Preliminary Consultation
MONTGOMERY COUNTY HISTORIC PRESERVATION COMMISSION
STAFF REPORT

Address:	3 Primrose Street, Chevy Chase	Meeting Date:	3/24/2021
Resource:	Contributing Resource Chevy Chase Village Historic District	Report Date:	3/17/2021
Applicant:	William Curtin Outerbridge Horsey, Architect	Public Notice:	3/10/2021
Review:	Preliminary Consultation	Staff:	Dan Bruechert
PROPOSAL:	Building Modifications

RENDERINGS

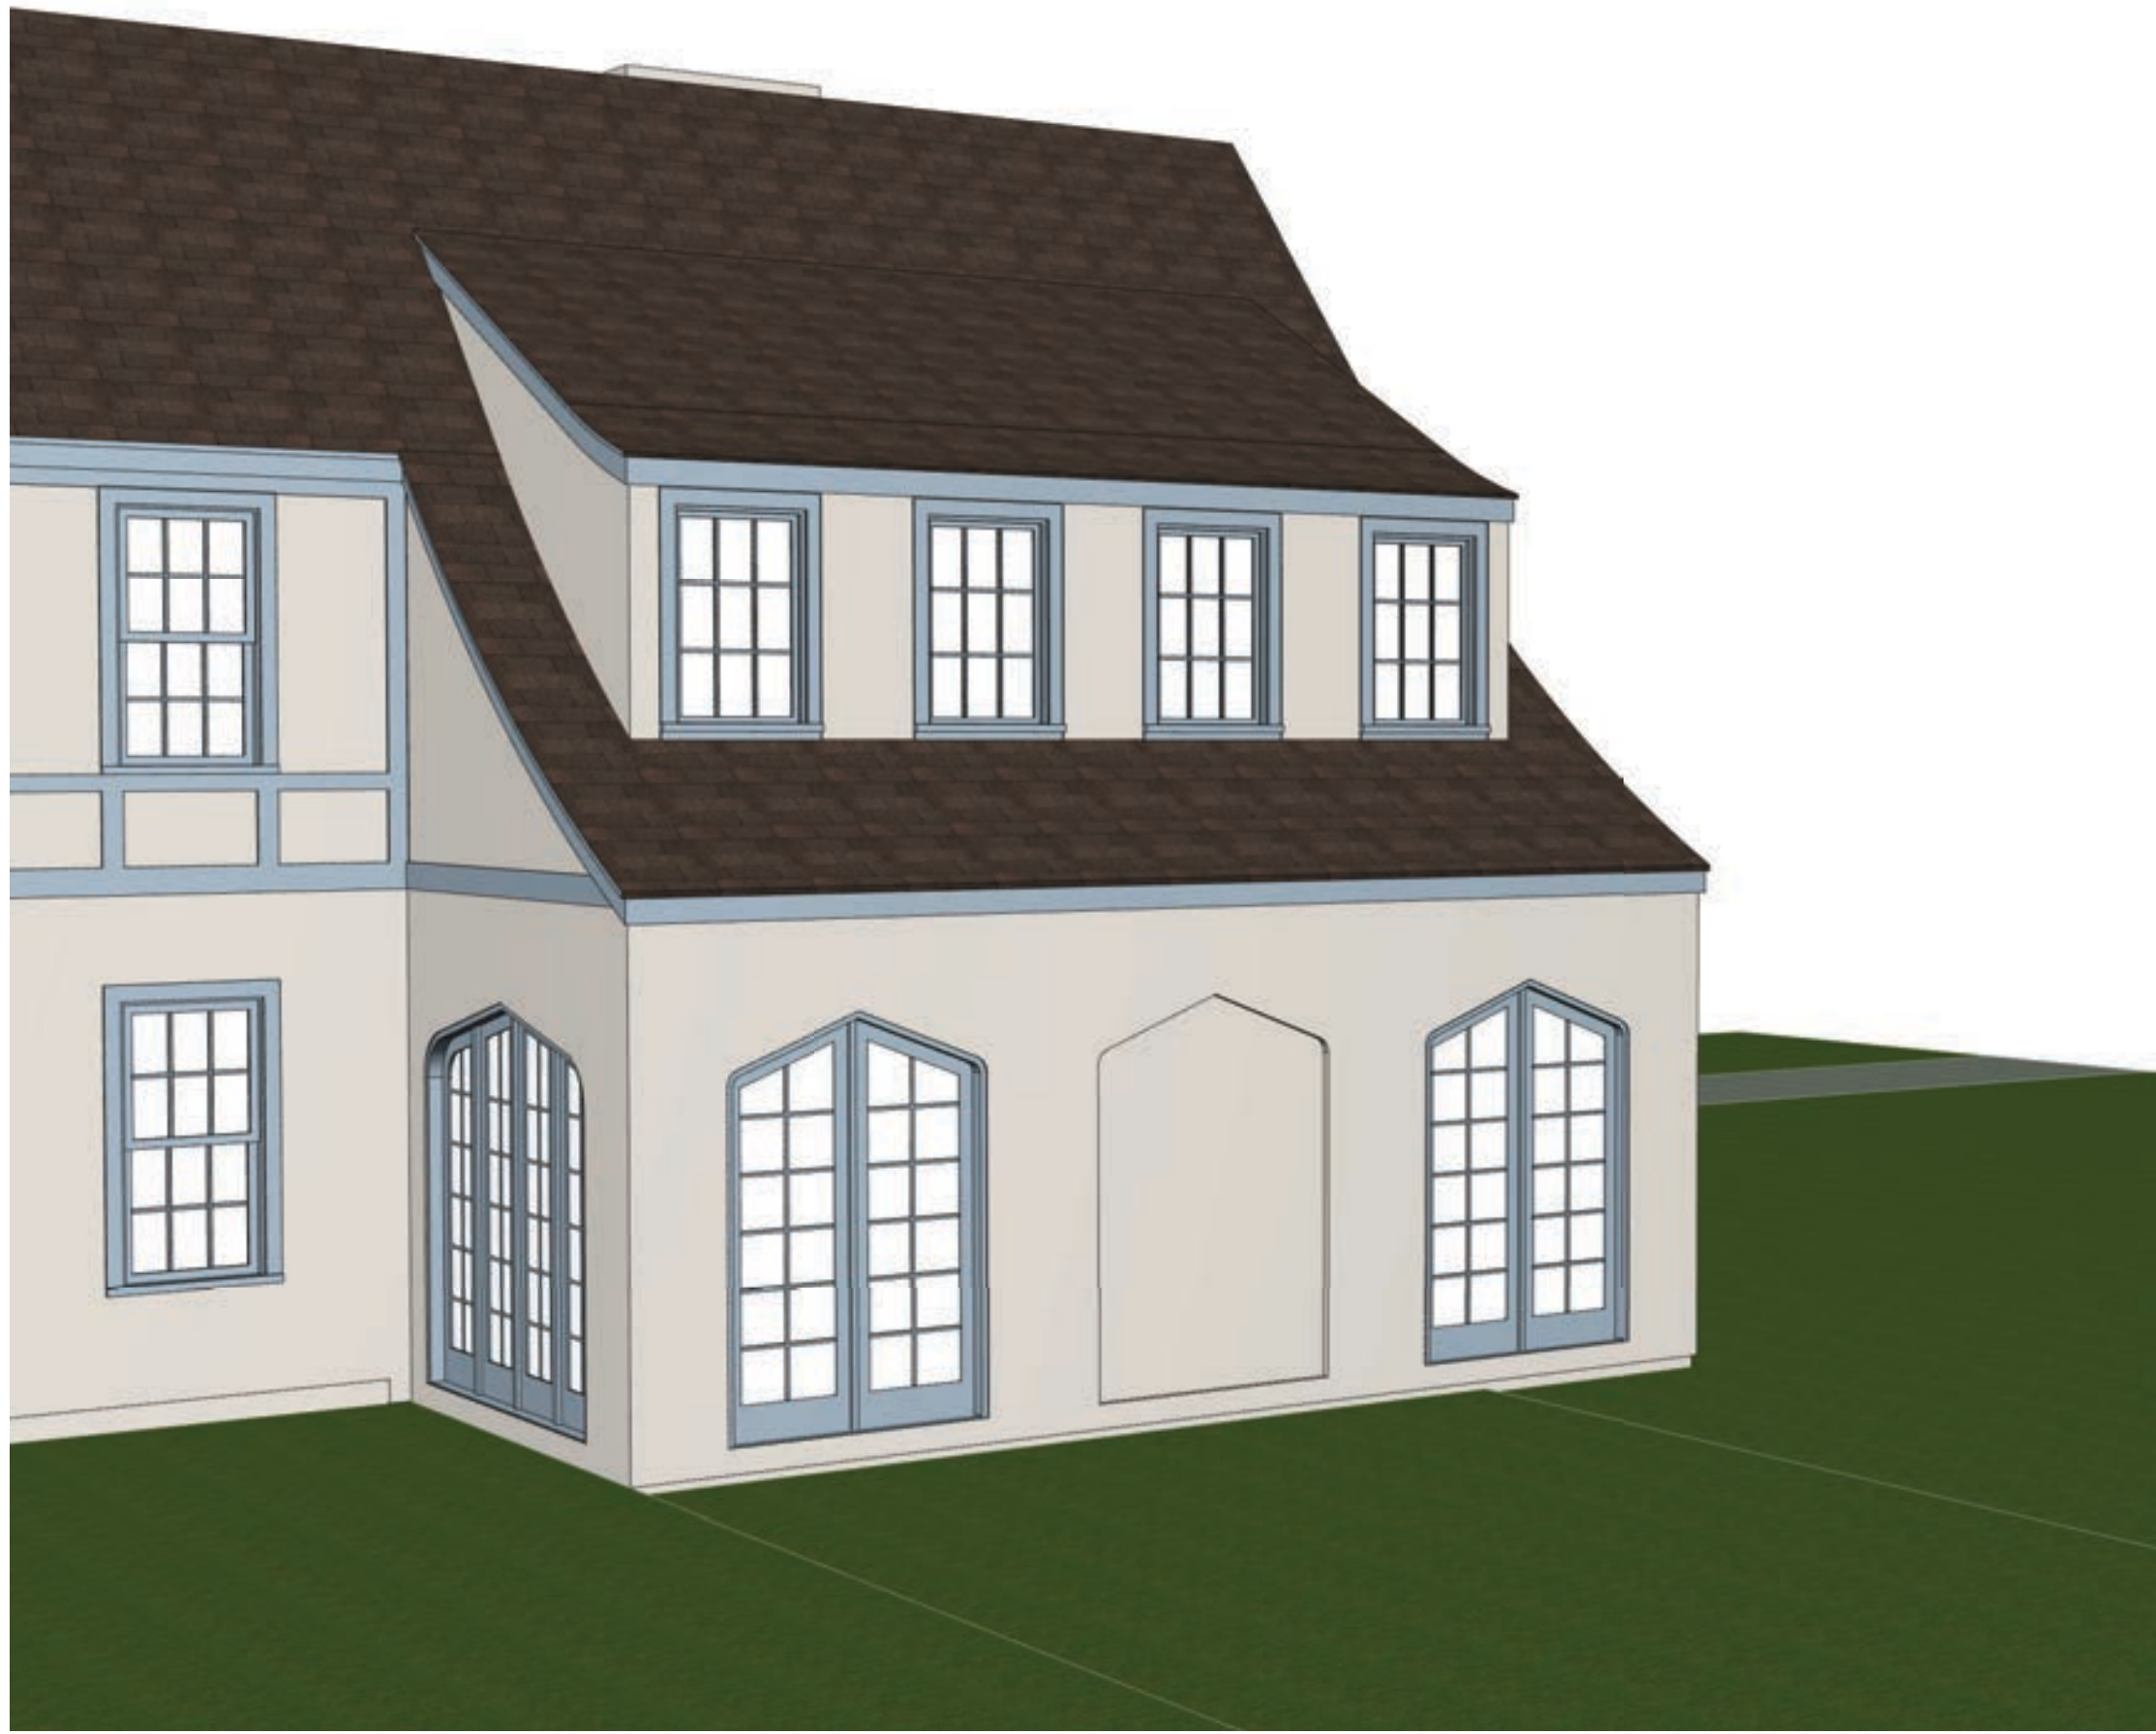
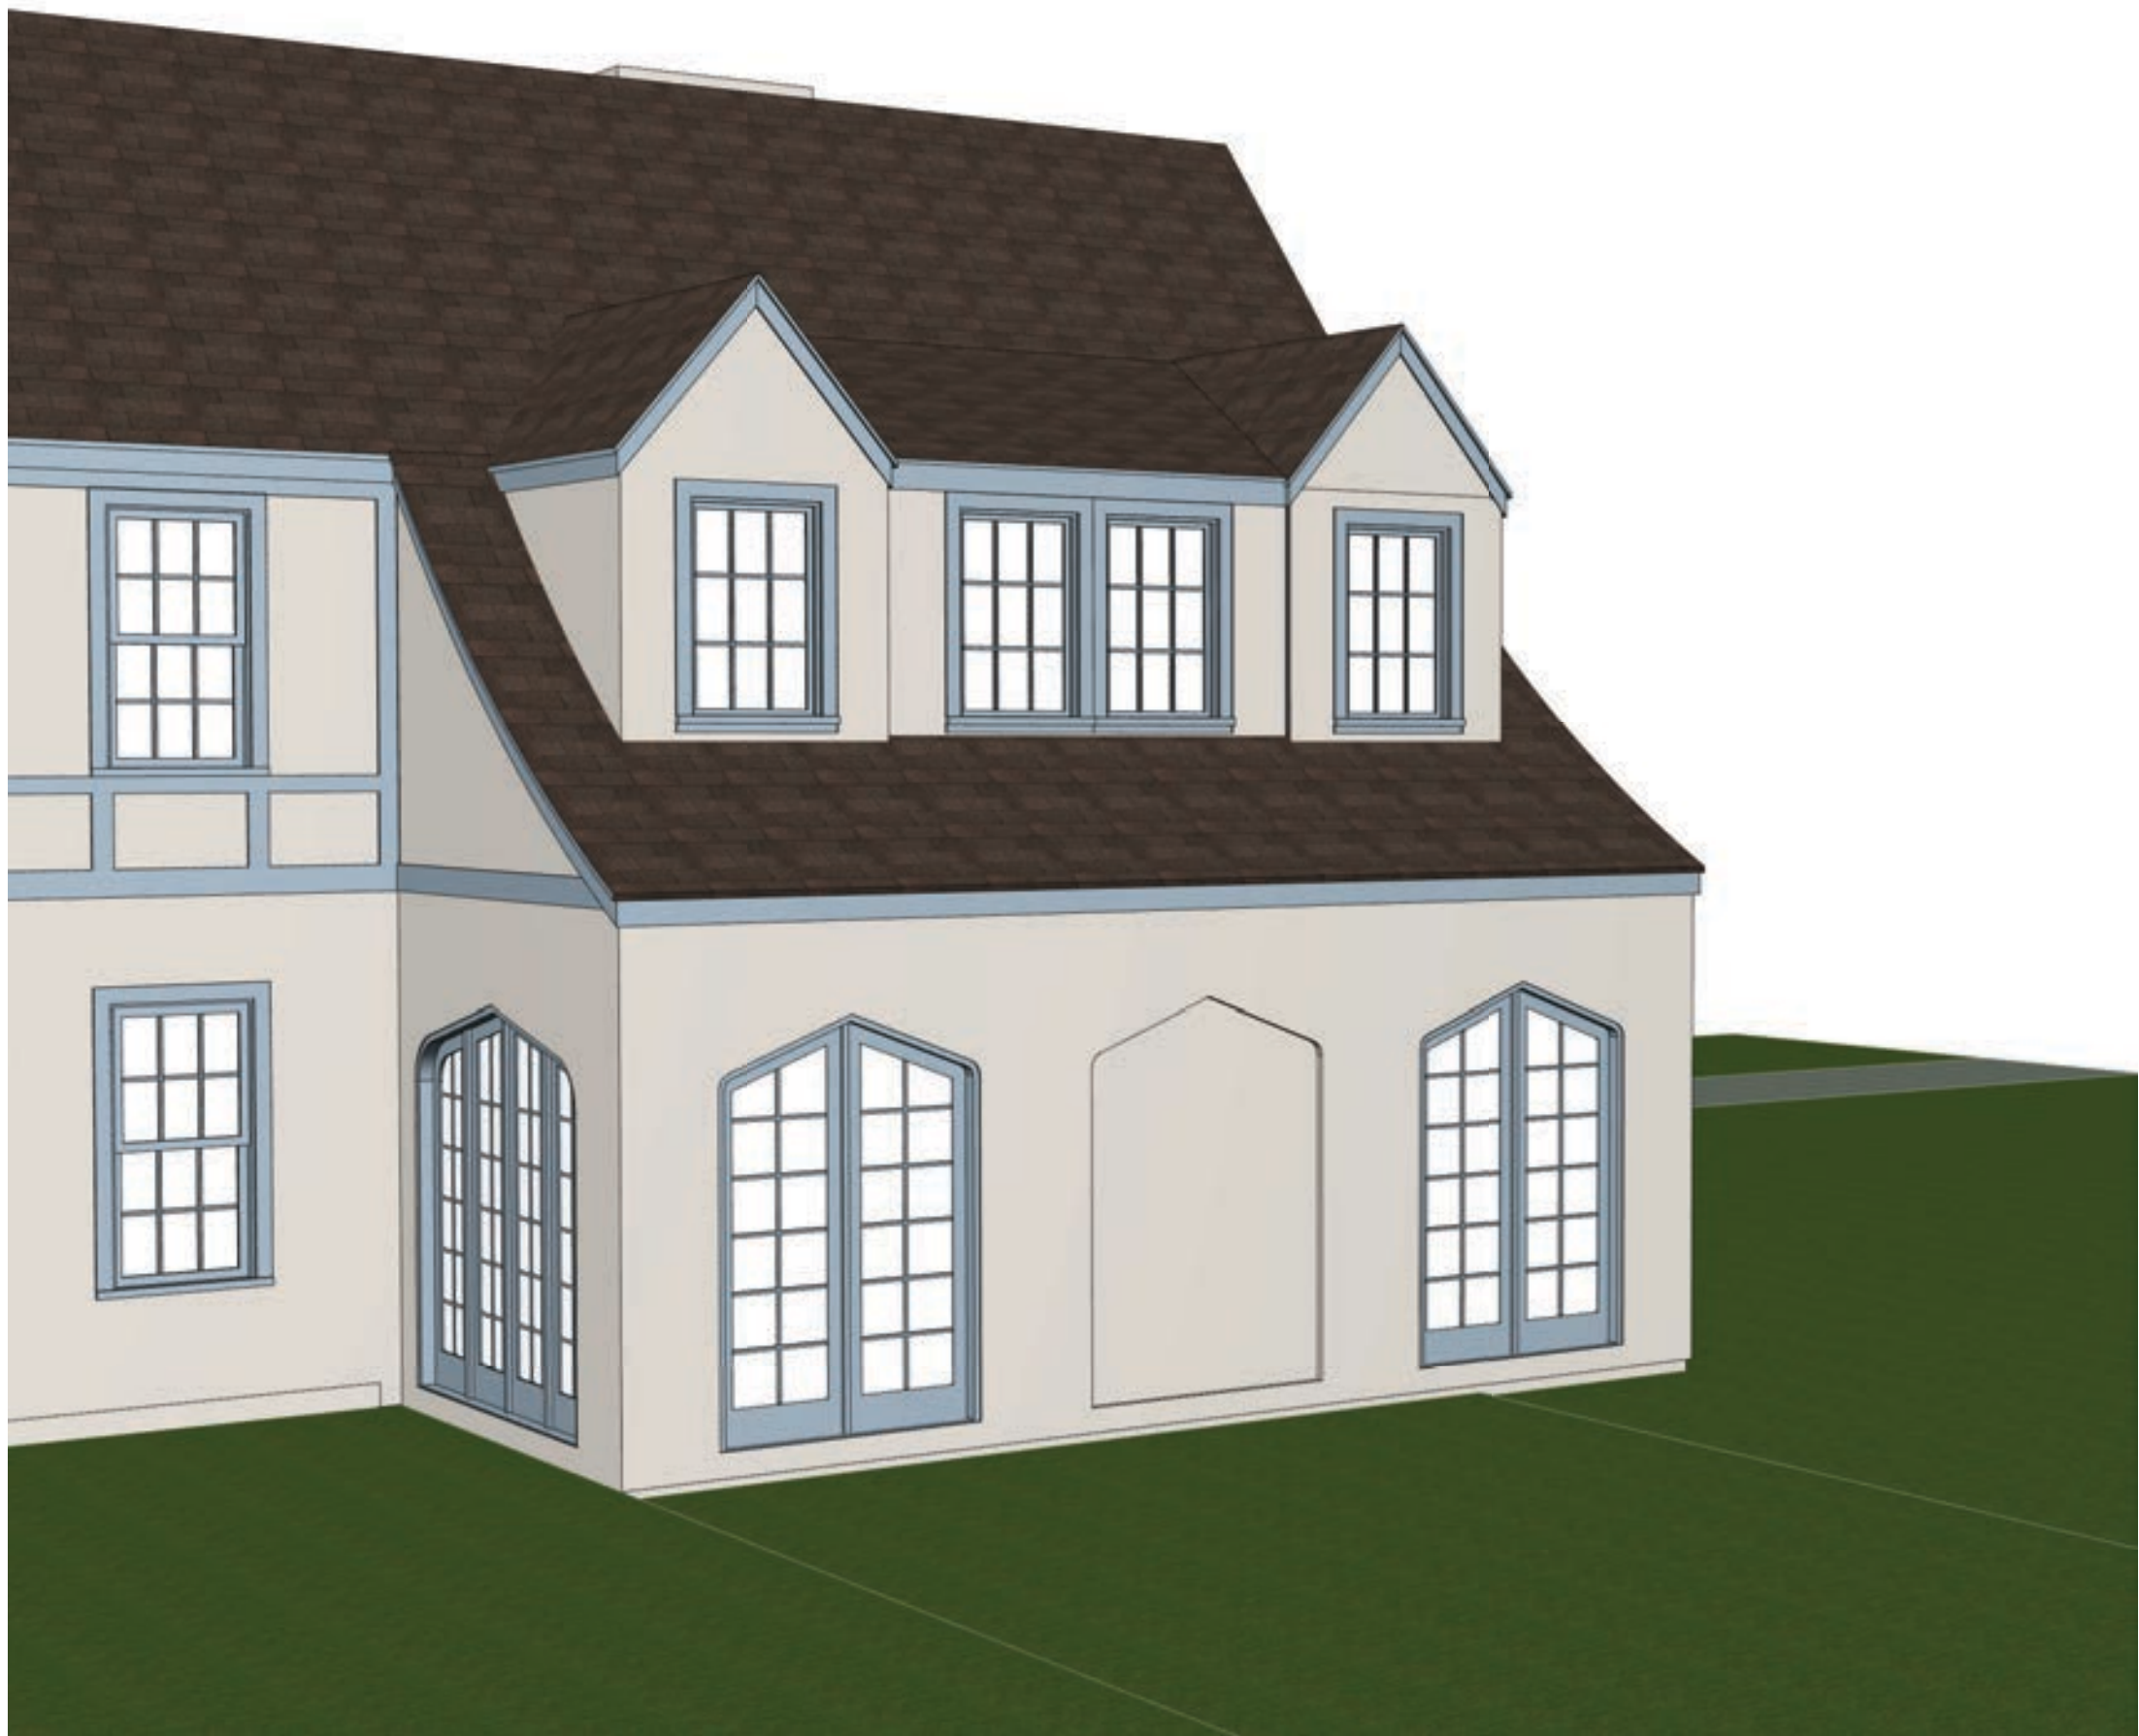
The submitted drawings include three design concepts for the HPC's consideration. All three options would match the stucco walls and slate roof found throughout the house. The Options are as follows:

- Option 1: a single shed dormer;
- Option 2: a pair of smaller gables with a shed roof in the center; and,
- Option 3: a pair of large gables with half-timbering.

Under a moderate scrutiny review, Staff finds that any of the three designs are approvable. Staff strongly supports Option 1 because its simple form will better blend in with the historic house without calling undue attention to a new architectural element that will be very visible from the streetscape. Staff finds Options 2 and 3, while well-designed, create additional roof shapes that could visually distract from the already complex house form.

Staff Recommends the applicant makes revisions based on the HPC's feedback and returns for a HAWP.
